DART SERVICE INSTRUCTION

TO AMEND INSTALLATION INSTRUCTIONS GA129-2 REV D AND INSTRUCTIONS FOR CONTINUING AIRWORTHINESS ICA129-2 REV 0 REF FAA STC: SH4785NM

REF TCCA STC: SH93-82 REF EASA STC:10017003 REF ANAC STC: 2009S12-01

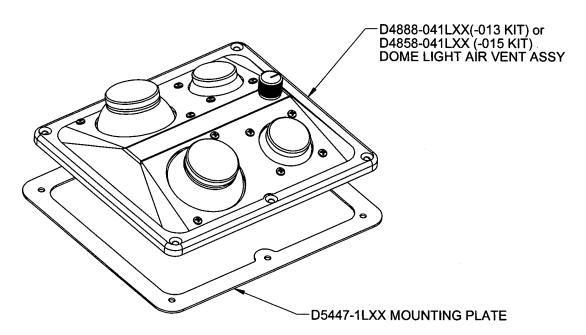
It has come to Dart's attention that on some AS 350 aircraft, the D350-833-013/-015LXX Dome Light Air Vent may not completely cover the cutout in the ceiling panel. The purpose of this Dart Service Instruction (DSI) is to amend Installation Instructions GA129-2 and Instructions for Continuing Airworthiness ICA129-2 to add the D5447-1LXX Mounting Plate to cover any small gaps around the D350-833-013/-015LXX Dome Light Air Vent.

The D5447-1LXX Mounting Plate installs between the D4888-041/D4858-041LXX Dome Light Air Vent Assy and the aircraft ceiling panel utilizing the same fasteners as the standard installation. Operators may trim the D5447-1LXX Mounting Plate, as required. It is acceptable to use longer installation fasteners of the same base P/N, if required.
